Subject: Re: Richardson Road Tennis Courts Renovation

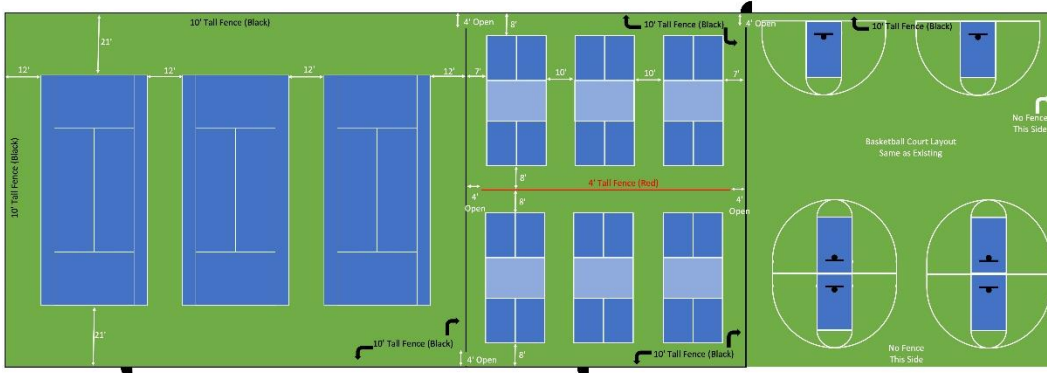
Attached is the layout. The original bid called for four pickleball courts, but you can fit six courts in there. The USAPA requires that there be 5' from the pickleball sideline to the fence and 10' between the pickleball courts. We meet that specification with six courts.

We would need to get another two sets of pickleball posts, nets, center straps and center anchors though. Also, we'd have to set the footers and center anchors. The total additional cost to add an extra two pickleball courts is \$4,000.
